**NOTE ON
AMENDMENT TO ENVIRONMENT CLEARANCE**

**OF
3X 660 MW SUPER CRITICAL COAL BASED THERMAL POWER PLANT
THERMAL POWERTECH CORPORATION INDIA LTD
at**

PROJECT: **3x660 MW SUPER CRITICAL COAL BASED THERMAL POWER PLANT**

SUBJECT: **Request for Amendments to Environment Clearance**

FIG – 1 MAP SHOWING THE TPCIL SITE AND ACCESSORIES

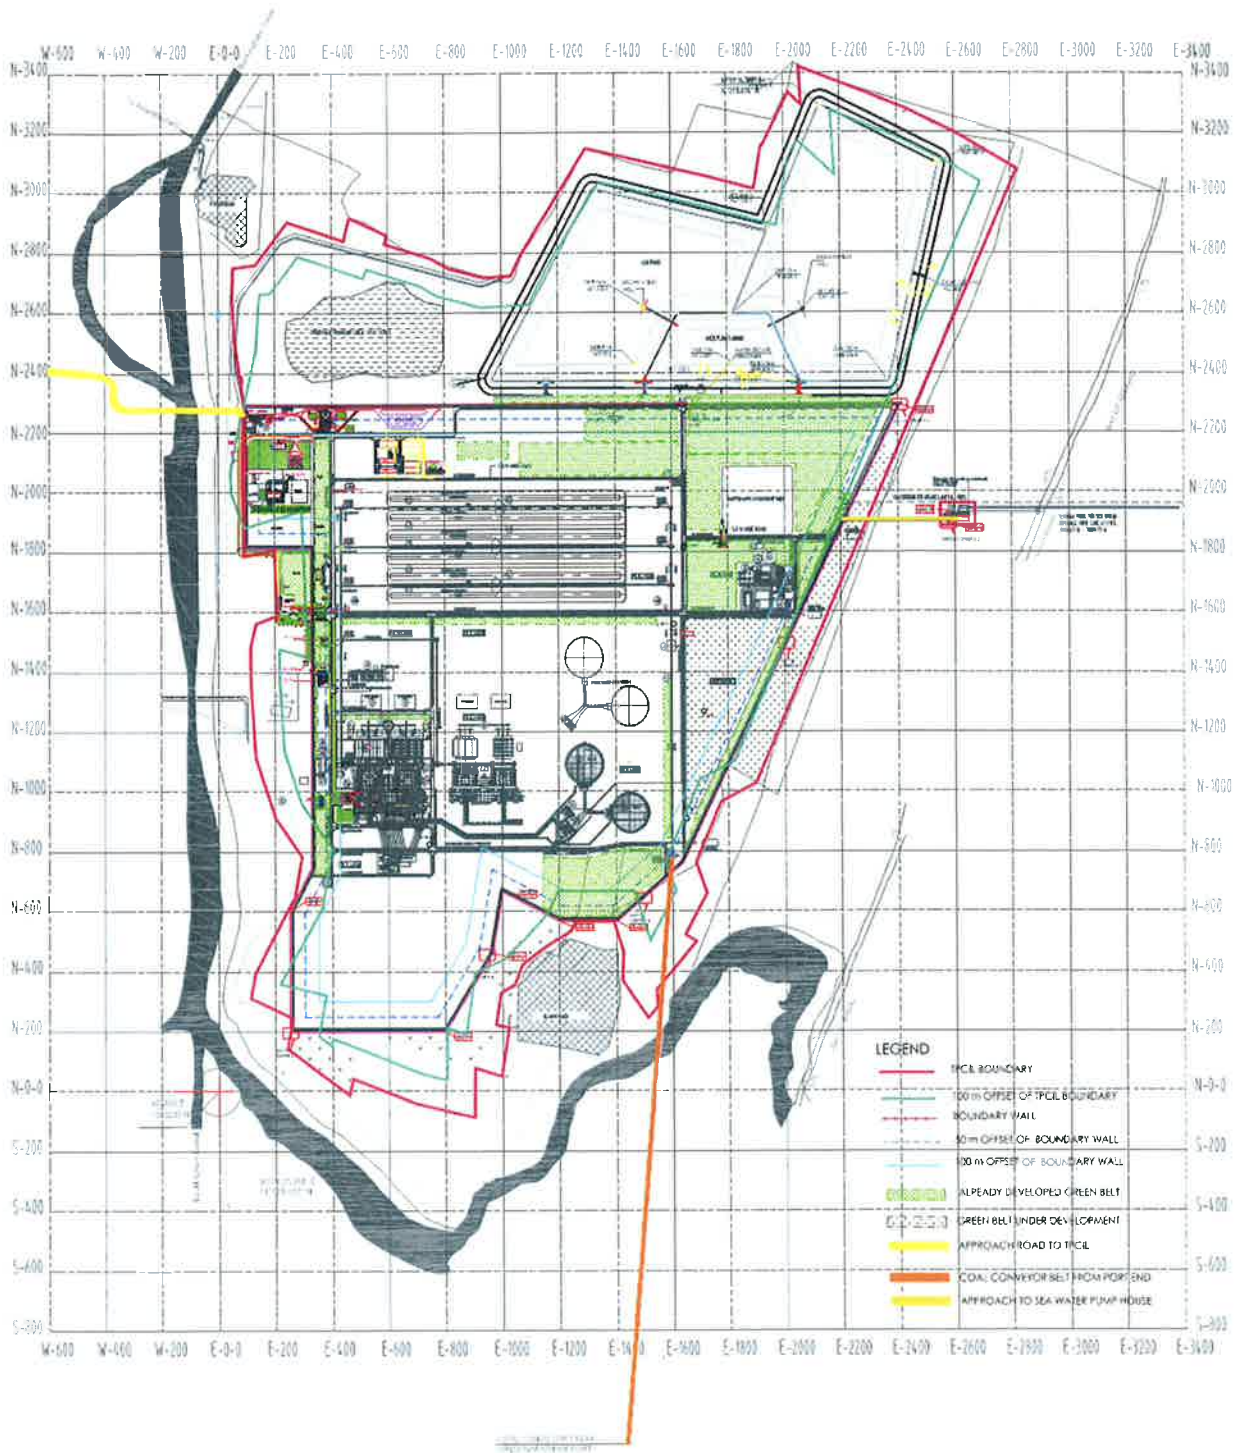
The total land estimated for the project at the time of finalization of draft EIA was 1367 acres and another 100 acres for the coal corridor etc. However during final handover of the land by APIIC to the project proponent, it was found that the total land is 1408.70 acres based on survey. Thus, the total land allotted by APIIC is 1408.70 acres instead of 1367 acres for the main plant area.

TPCIL had purchased 30 m wide corridors for passage of its Coal Conveyor (23.34 Acres) and construction of Plant Approach Road (12.28 Acres). The original area envisaged for coal corridor was about 100 acre, which has now been optimized to 23.34 acre.

The area acquired for plant approach road is 12.28 acre. Part of the above two lands is under CRZ and CRZ Clearance for the same has been obtained vide Central CZMA letter dated 5th Dec 2011. The copy of the CRZ clearance letter is attached with the document.

An area of 16 acres has been acquired from private parties for construction of TPCIL Sea Water Pump House. This land is within CRZ and Clearance of Central CZMA has been obtained for the same vide letter dated 5th Dec 2011. The copy of the CRZ clearance letter is attached with the document.

Thus the increase of land is 9.47 acres (i.e.) from 1467 acres as given in the EIA report to 1476.47 acres as procured by TPCIL.

TPCIL requests MoEF&CC to approve the increase of land requirement from 1467 acres to 1476.47 acres as per justification given above.

FIG-2 Location of feeder shaver on toposheet

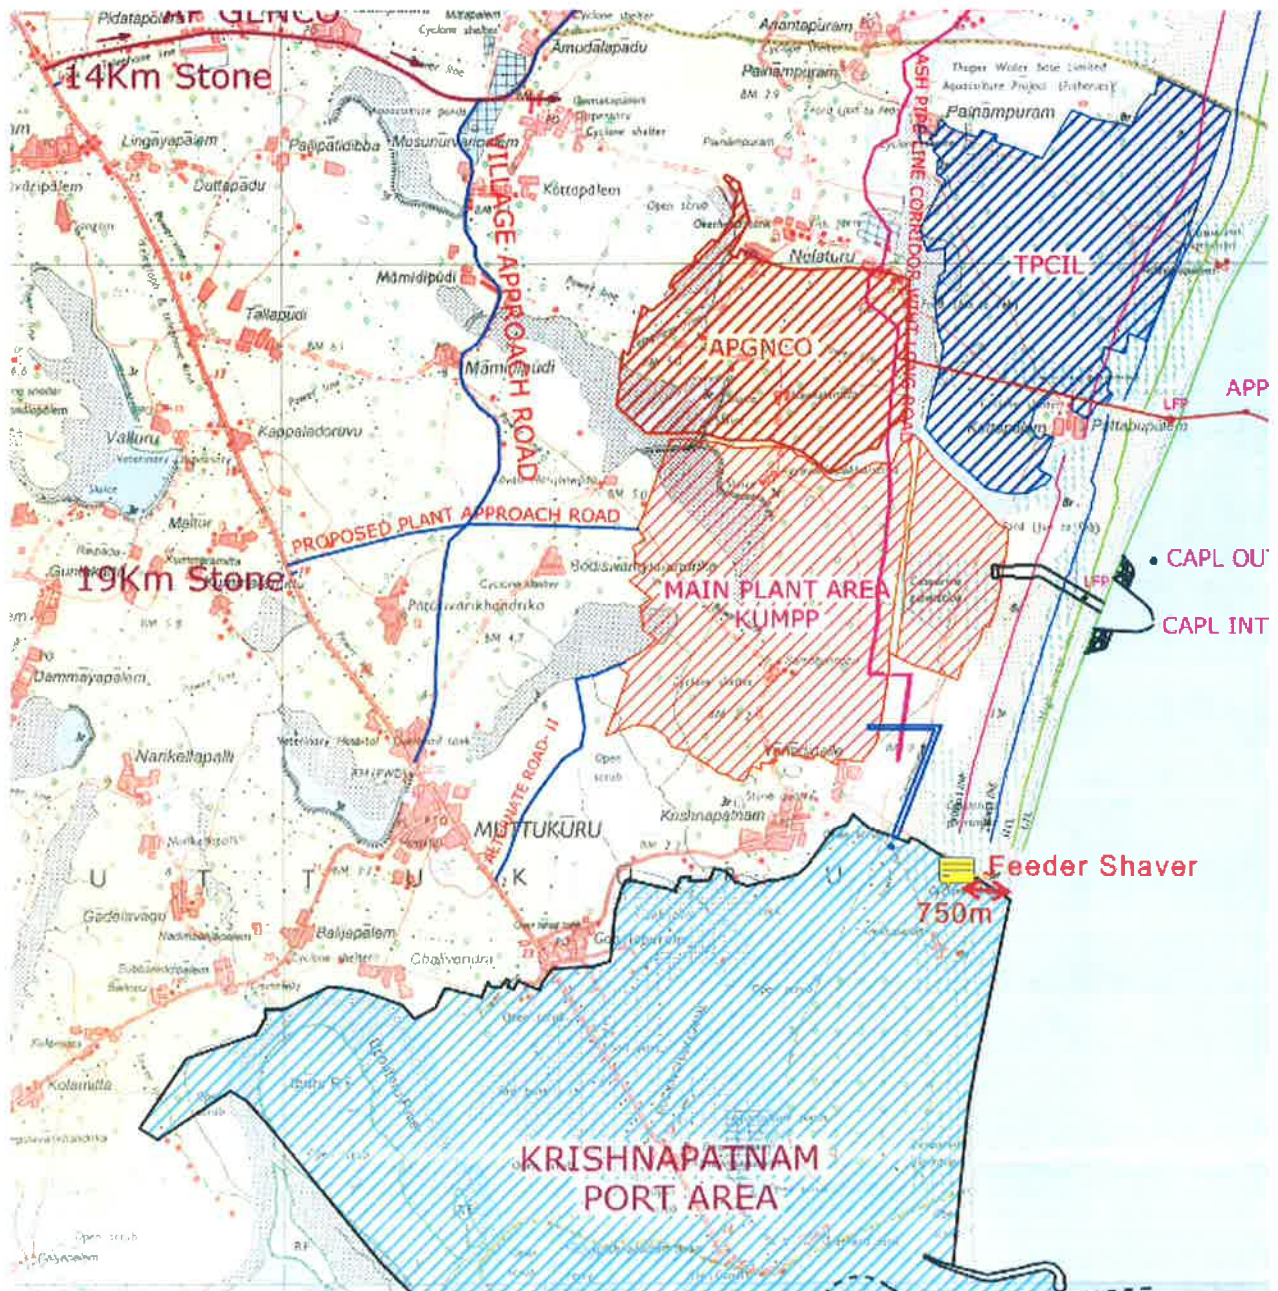
TPCIL has implemented an environment friendly PIPE CONVEYOR for conveying coal from the Krishnapatnam Port (North) to the coal handling plant located inside the power plant. During operation, it was observed that large lumps of indigenous coal were received and this could not be fed into the PIPE CONVEYOR. To overcome this problem a Feeder Shaver (A small scale coal breaker with dust extraction system) has been implemented which was not envisaged at the time of construction of the power plant. Location map of the feeder shaver and photograph of the same is given below:

TPCIL requests MoEF&CC to approve the installation of Feeder Shaver at Krishnapatnam Port as per justification given above.

FIG – 3 PLOT PLAN SHOWING THE GREENBELT DEVELOPMENT

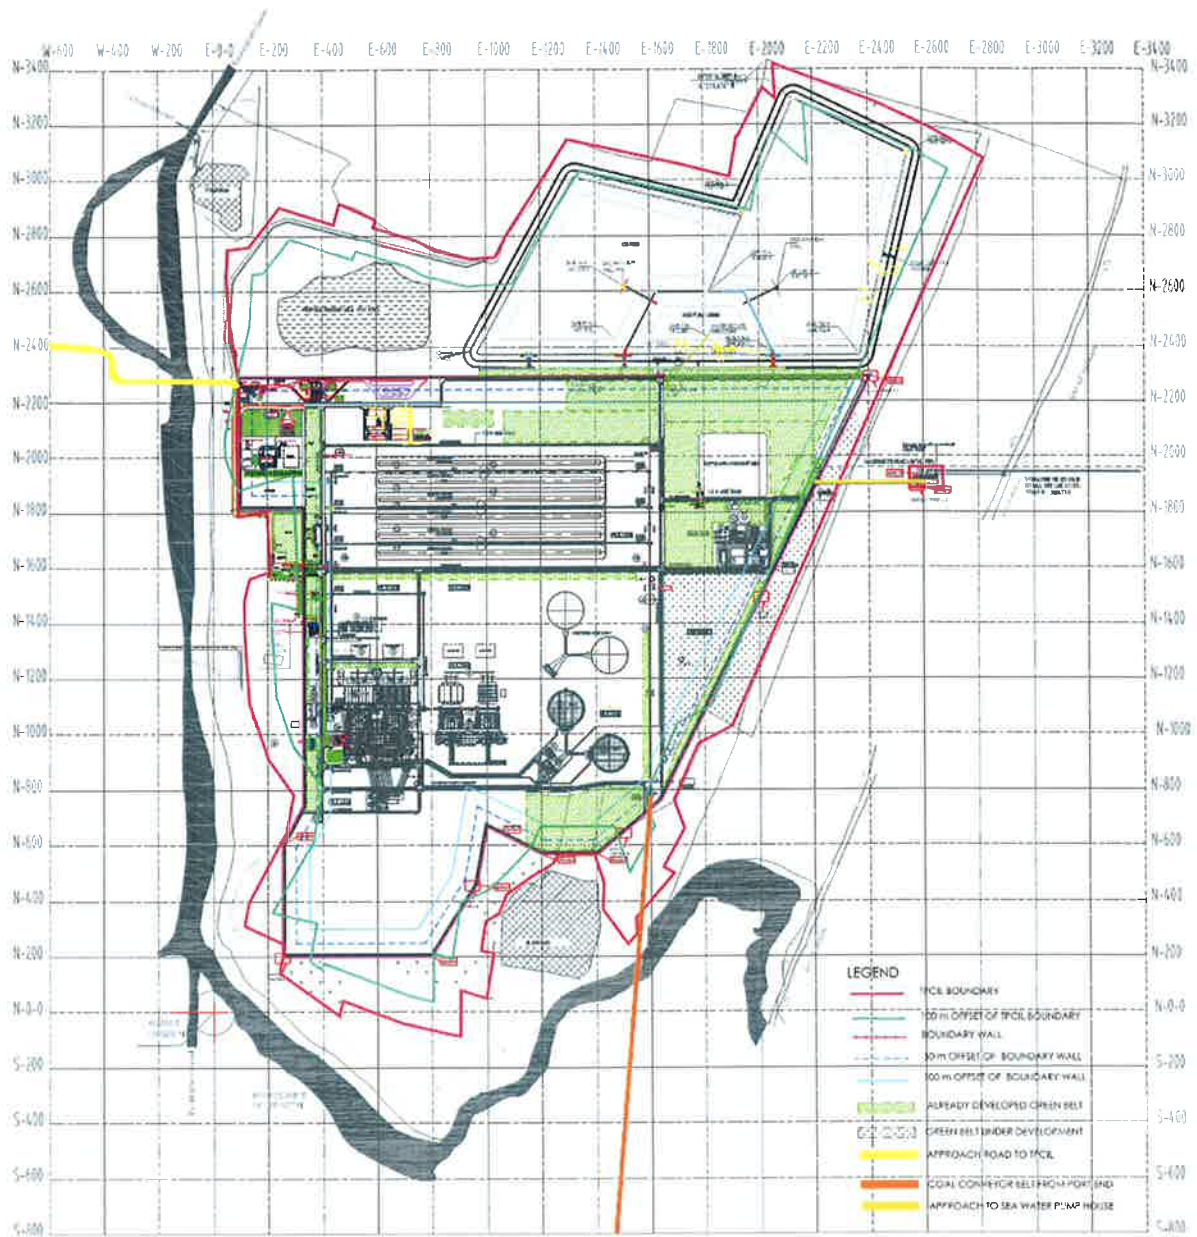
TPCIL has initiated the development of greenbelt during construction stage itself. Out of the total area 1408 acres, an area of 396 acres has been earmarked for greenbelt which is 28.13%. The EC has stipulated green belt of 100 m width on all sides. Based on the layout design, it has been found that the feasibility of developing green belt of 100 m was difficult in the Eastern and Western sides of the power plant area due to construction of non-plant buildings. However TPCIL is developing green belt of 50 m width in the Eastern and Western side. The following table summarizes the same.

TPCIL will maintain the total area of 396 acres green cover as committed. TPCIL has established a Nursery with in the plant premises and the photographs of the nursery and greenbelt developed as on date is given below.

TPCIL requests MoEF&CC to approve the development of greenbelt with a width of 50 m – 100 m instead of 100m width as justified above.
